# California High-Speed Train Project

RFP No.: HSR 11-16  
Design Variance Report

06/04/2012 ADDENDUM 2 - RFP HSR 11-16

Fresno Station Crossover  
Distance from Station

## Exhibit 8

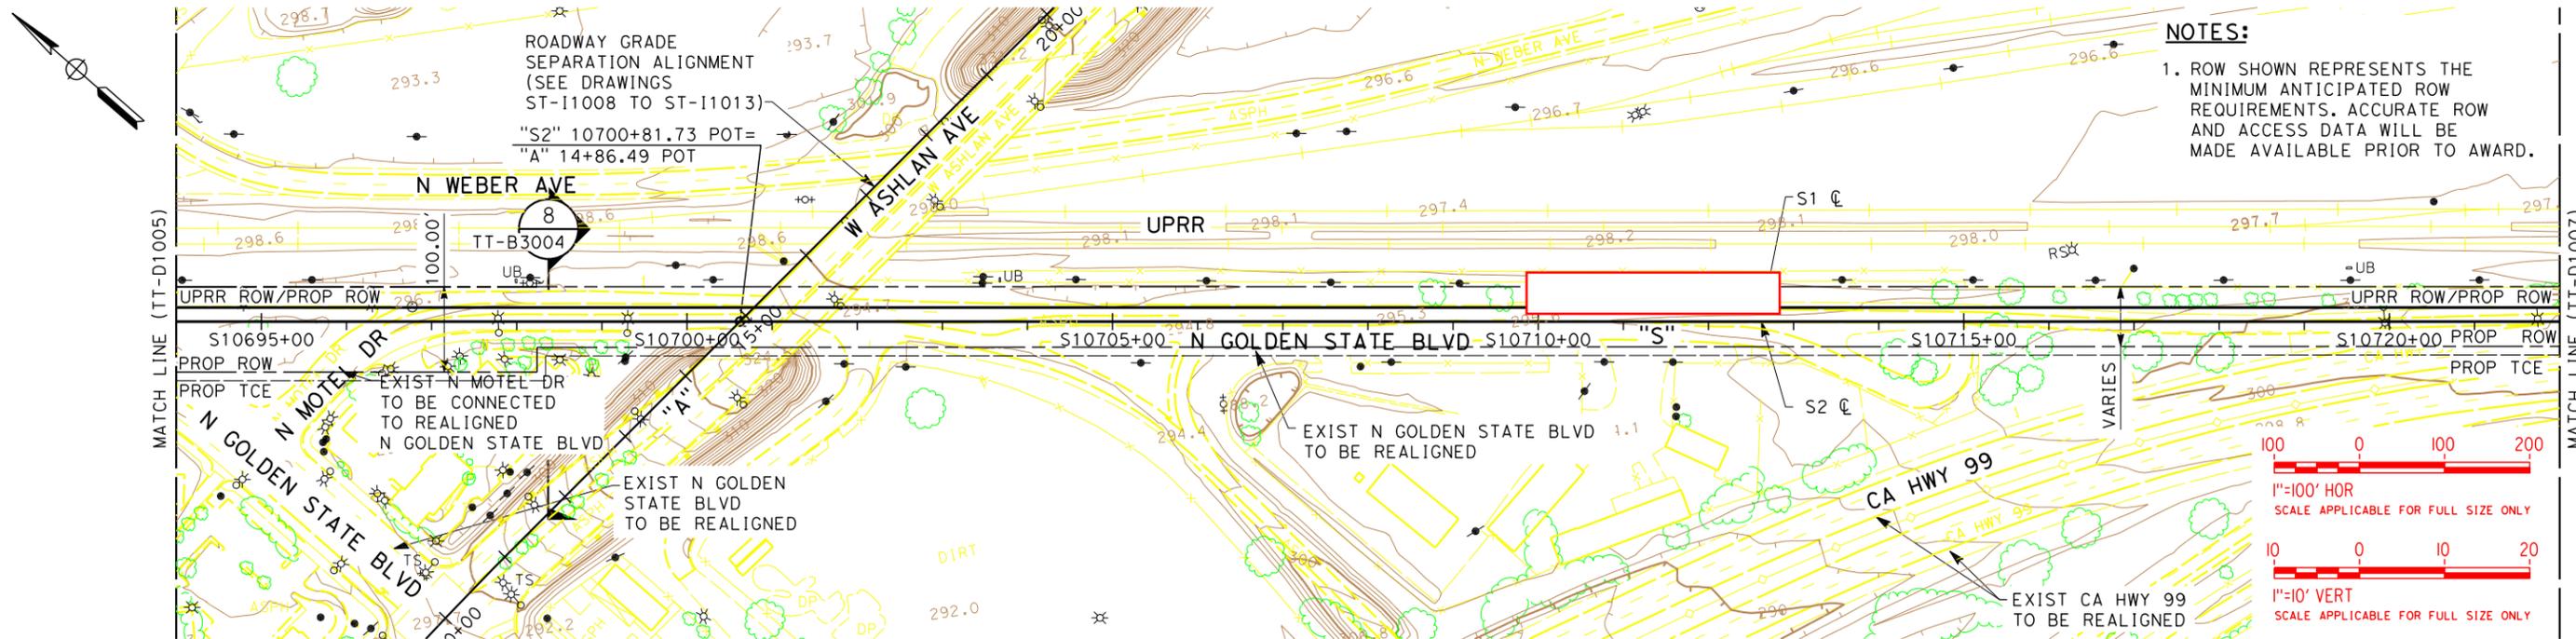
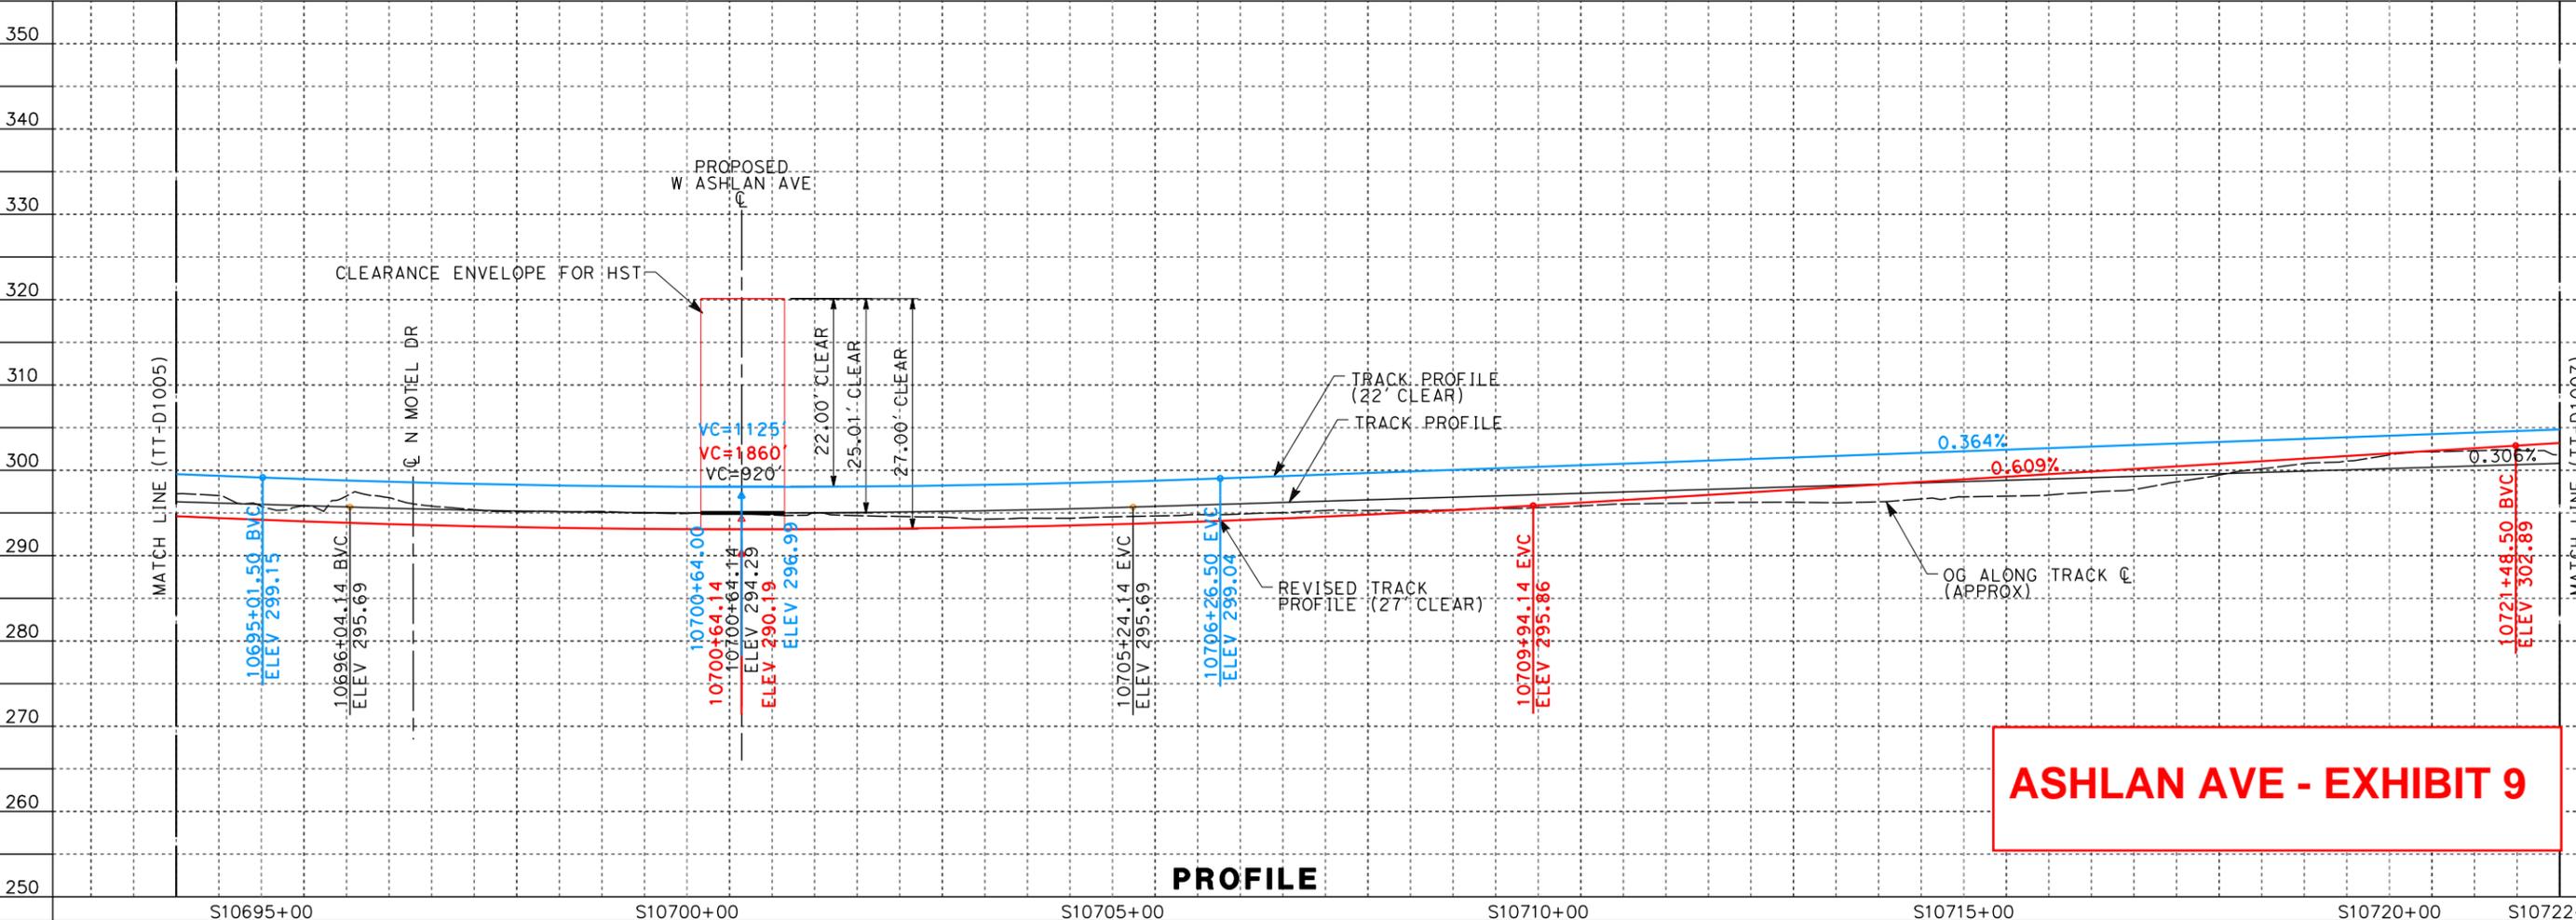
<p><b>CHSTP DESIGN REQUIREMENT</b> Include reference to drawings, design criteria, technical memos, specifications</p>	<p>TM3.2.1 – OCS requirements, Track work Flood elevation clearance</p>
<p><b>DESIGN CRITERIA REQUIRING A VARIANCE</b></p>	<p>The vertical clearance of 27 ft for installation of OCS system under new or planned over-crossing structure</p> <p>TOR 2.5 ft above flood elevation</p>
<p><b>REASON FOR REQUESTING VARIANCE</b></p>	<p>Any rise of profile of the new structure relative to the existing structure it replaces results in higher project impact, mitigation, delays and cost.</p> <p>Lowering HST will result in track work below estimated flood elevation, which may require boat-section and pump station</p> <p>To eliminate the requirement to lower the track work below the estimated flood elevation a variance to reduce the vertical bridge clearance to 22ft would be required</p>
<p><b>JUSTIFICATION FOR VARIANCE</b></p>	<p>To minimize the dip in the alignment under Ashlan Ave, maintain track elevation above existing ground and 2.5ft above estimated flood elevation.</p> <p>Achieves best possible vertical track alignment with minimum grade change, eliminates need for boat section and pumping equipment/maintenance. Provides the best track alignment profile for the least cost</p>

1. With an approved DVR, consider 24 ft clearance, as permitted for crossing under existing structures, since the existing constraints bounding the replaced Ashlan Ave overhead are prohibitive from further adjusting the roadway profile. Provide 2 ft tall walls/boat section to protect against local flooding.

<p><b>PROPOSED ALTERNATIVE DESIGN REQUIREMENT</b></p>	<p>Allow minimum clearance under replacement bridge to be <b>22 to 24ft</b>, this equates to TM 3.2.1 Directive Drawing for existing bridges up to 120 ft wide with free running OCS and reduced System Depth. Use Up to 2 ft of Walls/boat section for flood protection</p> <p>Or</p> <p>Allow deeper track work construction below flood elevation, while protected by a boat-section and pump station may be needed</p>

**Clinton Ave - Exhibit 7**

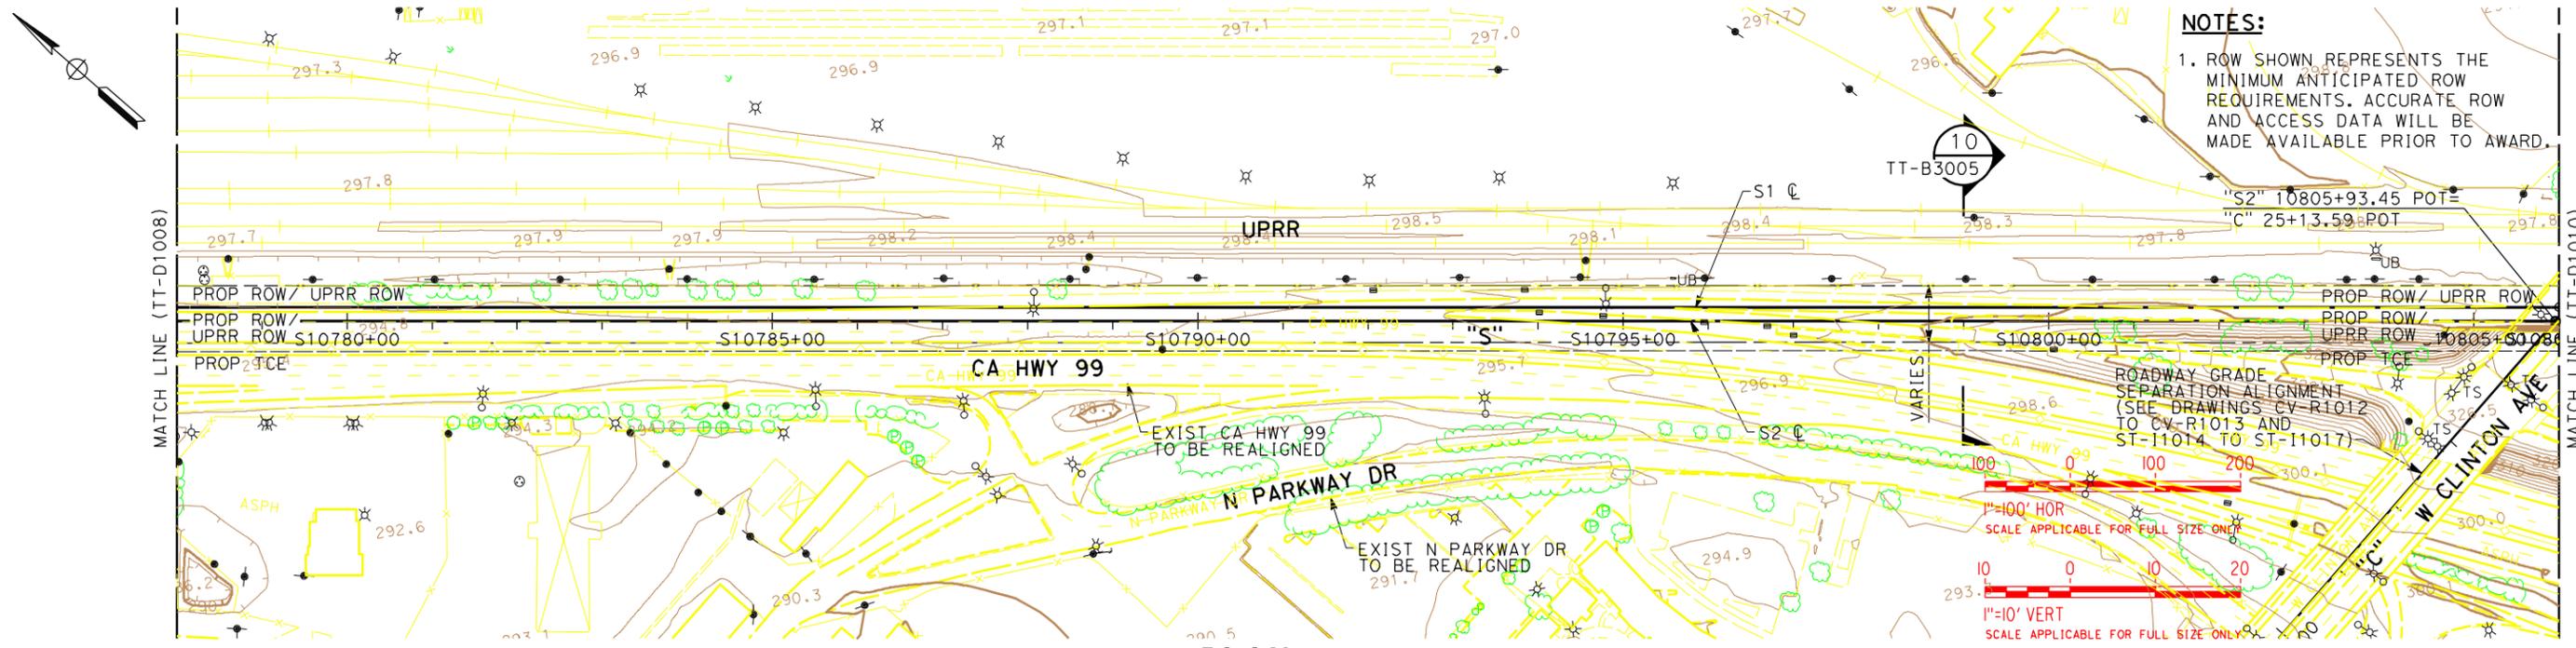
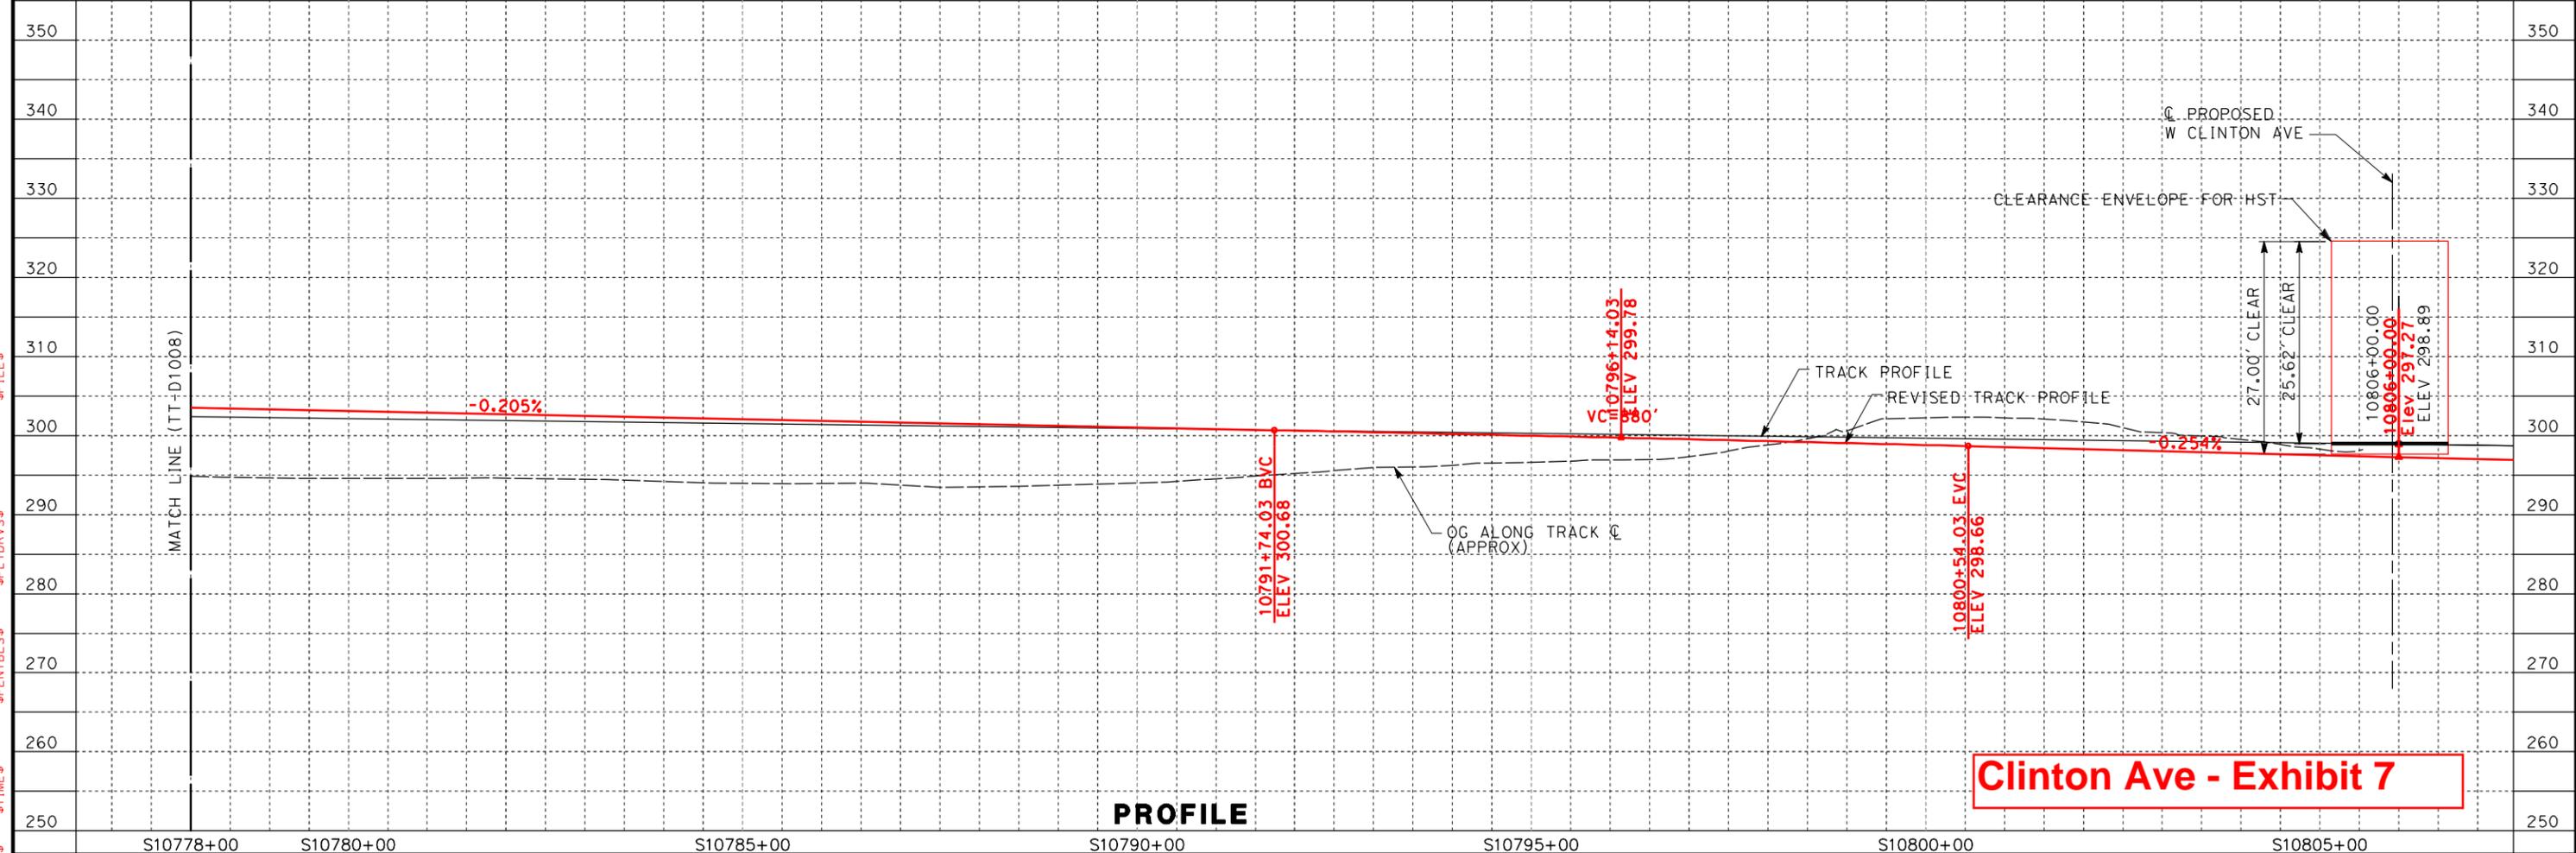
<p><b>CHSTP DESIGN REQUIREMENT</b>                  Include reference to drawings, design criteria, technical memos, specifications</p>	<p>TM3.2.1 – OCS requirements,                  Track work Flood elevation clearance</p>
<p><b>DESIGN CRITERIA REQUIRING A VARIANCE</b></p>	<p>The vertical clearance of 27 ft for installation of OCS system under new or planned over-crossing structure</p> <p>TOR 2.5 ft above flood elevation</p>
<p><b>REASON FOR REQUESTING VARIANCE</b></p>	<p>Any further rise of profile of the new structure results in higher project impact, mitigation, delays and cost.</p> <p>Lowering HST will result in track work below estimated flood elevation, which may require boat-section and pump station</p> <p>To eliminate the requirement to lower the track work below the estimated flood elevation a variance to reduce the vertical bridge clearance to 24ft would be required</p>
<p><b>JUSTIFICATION FOR VARIANCE</b></p>	<p>To avoid additional environmental impact, mitigation, ROW, Cost, and delay</p>

<p><b><u>A- Roadway Profile Adjustments</u></b></p> <p>Modifying the Clinton Ave overhead replacement structure to raise the roadway profile further so that clearance over HST can be raised to 27 ft is not feasible due to geometric factors including the following:</p> <ul style="list-style-type: none"><li>• Compared to 15% design, the roadway profile has already been raised by approximately 1.5 ft to offset clearance errors associated with the initial mapping accuracy of +/- 3 ft.</li><li>• The profile rise impact already has resulted in modification of Weber/Clinton intersection by raising the intersection and tapering the effects on approach roadway (see Exhibit 3). This "refinement" which is beyond the DEIR/EIS footprint has already been noted to the agencies, and considered to be minor refinement to avoid/minimize impacts. When impacts exceed "minor" level, reevaluation and recirculation of DEIR/EIS may be required.</li><li>• Further raising of Clinton Ave overhead structure to achieve 27' clearance will require profile grade modification which can impact both approaches, Weber street intersection and profile of the structure approaching the interchange, SR99 crossing and ramps.</li><li>• The profile grade modification will further raise the Weber street intersection, rise the approaching roadways even further, increase the footprint impact to the intersection, further impact the adjacent parcels, and may require retaining wall which can impact property access adjacent to this intersection.</li><li>• Note that geometry, and width of the structure includes several exceptions, pending review and approval of Caltrans.</li></ul> <p><b><u>B-DVR 24 ft clearance, w/ no walls/Boat Section</u></b></p> <p>Original HSR profile design was based on preliminary mapping. In addition, in absence of flood elevation information, a conservative approach of keeping TOR 4 ft above average existing ground elevation in the vicinity was</p>

<p><b>PROPOSED ALTERNATIVE DESIGN REQUIREMENT</b></p>	<p>Allow minimum clearance under the new replacement bridge to be <b>24 ft (DVR 24 ft)</b> as permitted condition for existing structures *, which also will avoid the need for walls/boat-sections,</p> <p>OR</p> <p>Allow minimum clearance under the new replacement bridge to be <b>25.5 ft (DVR 25.5 ft)</b> as permitted condition for existing structures *, as shown in Draft 30%, however will require a <u>1.5 ft walls/boat section</u> and potentially pumping facilities,</p> <p>OR</p> <p>Maintain standard <b>27 ft clearance</b>, but provide deeper <u>3 ft walls/boat section</u> and potentially pumping facilities</p> <p>* as permitted by TM 3.2.1 for crossing under existing bridges of less than 160 ft width.</p>
